## REMARKS

Appendix A  
VERSION WITH MARKINGS TO SHOW CHANGES MADE

FIG. 11

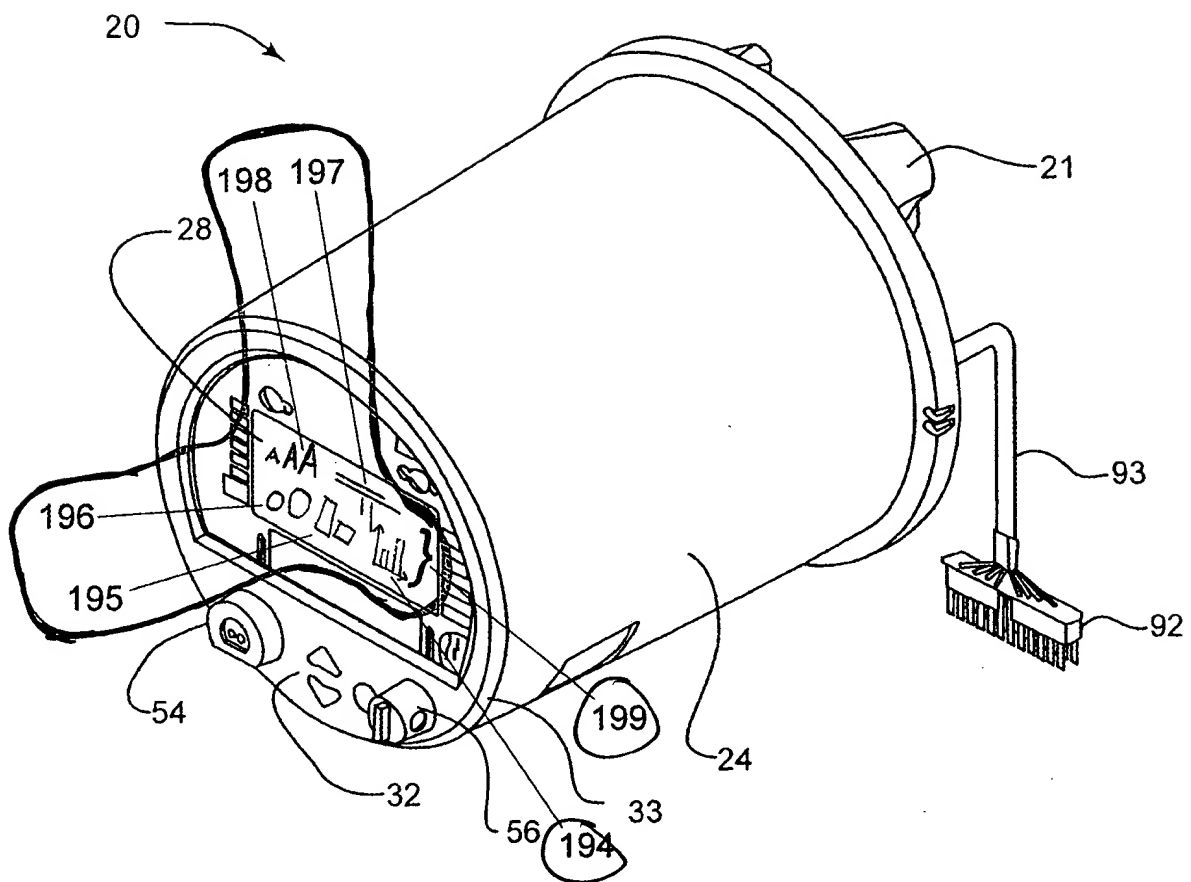
The drawings stand objected to under 37 CFR 1.83(a) as failing to show all features of the invention claimed. Figure 11 has been amended in the drawings to better describe the claimed features. The figure amendment is supported by the specification on at least page 10, lines 9-12 and page 11, lines 20-22. No new matter has been added.

Claims 1-33 stand rejected under 35 U.S.C. 112 as containing matter which was not described in the specification in such a way as to enable one skilled in the art to which it pertains, or with which it is most nearly connected, to make and/or use the invention. The examiner indicated that it was unclear what comprises the "graphic user interface" or how it operates.

As indicated above, the "graphic user interface" or "GUI" is shown in the amended figures. In addition, the applicants submit that the "GUI" is sufficiently described in the description to enable one skilled in the art to make and/or use the invention. Reference is especially made to the description from page 10, line 3 to page 12, line 20. Therefore, applicants respectfully request that the rejection of claims 1-33 be withdrawn.

**(Twice Amended)** Referring to FIGS. 1-3, the S-base and A-base revenue meters' cover 24, and the Switchboard revenue meter's cover 48, are at least partially transparent. The transparency permits viewing of the meter's display 28 including a graphic user interface (GUI) 199 (Fig. 11) [(not shown)] without having to remove the cover 24. As mentioned above, the meter cover 24 provides the context adaptable input device such as the keypad 32 for interacting with the revenue meter while the meter cover 24, 48 remains in place. Artisans will appreciate that the keypad 32 can be replaced with other context adaptable input devices, such as a touch screen 1100, a mouse 1110, a track ball 1120, a light pen 1130, a membrane switch 1140, joystick 1150, dial 1160, or other similar devices.
